draft Meeting Summary **Utah Water Quality Standards Workgroup June 8, 2020**

Kanab Creek Use and Value Assessment, TDS (total dissolved solids)

Best Friends Animal Society's comments

The following memorandum provides comments to the Kanab Creek – Use and value Assessment and Revised Criteria for Total Dissolved Solids, Utah Department of Environmental Quality, Version 1.3, March 9, 2020. Generally, the document lacks specificity regarding the processes that contribute to TDS loading in the Upper Kanab Creek Watershed and the need for changes to the TDS criteria. Based on the comments below, we recommend that additional supporting analyses should be performed to address the impact to lower watershed resources due to changing TDS criteria in the upper watershed during both the irrigation and non-irrigation seasons. Specific analyses may include, but not be limited to: nutrient analyses, piper diagrams, groundwater investigation, and agricultural practices in the Alton area.

Geologic Map of the Kanab 30' x 60'

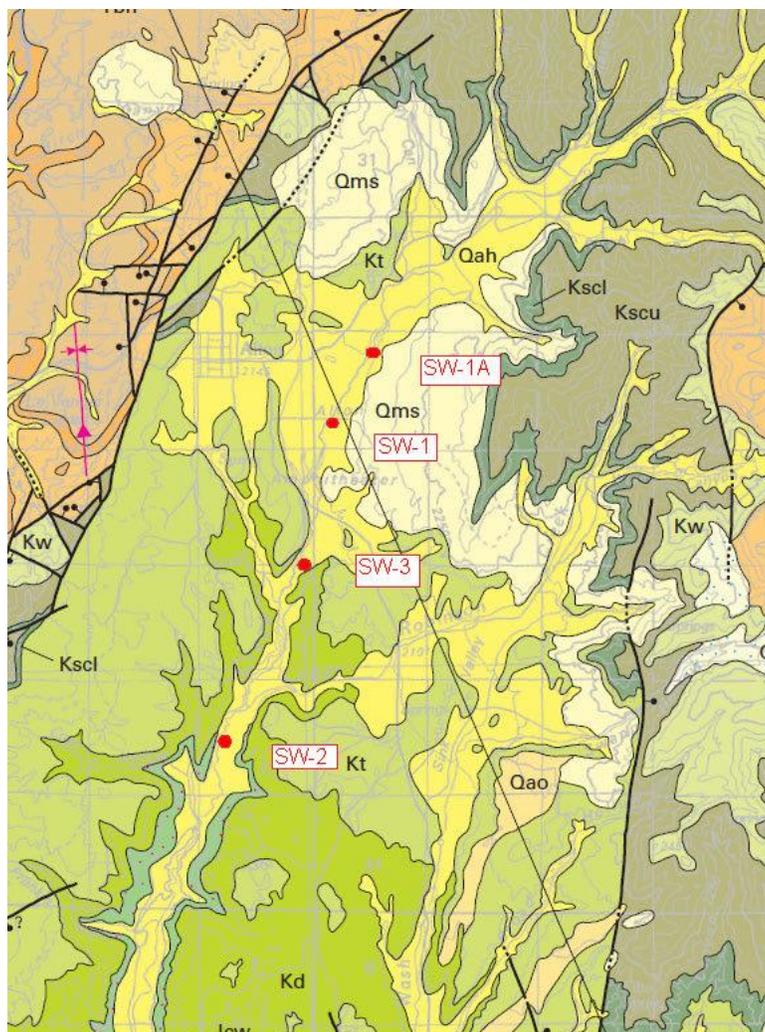
The Geologic Map of the Kanab 30' x 60' Quadrangle, Utah and Arizona (USGS, Sable and Hereford, 2004) indicates that the upper formation of the Alton Valley is Holocene Alluvium (Qah) consisting of sand, silt, clay, and gravel of several cut-and-fill deposits. It is likely that following erosion of Tropic shale in the Alton area, coarser grained sediments from upstream formations (Straight Cliff Formation and others) filled the Alton Amphitheater. While the Tropic shale underlies the Holocene alluvium in the Alton Valley, it is more likely the alluvial sediments were derived from upstream sources.
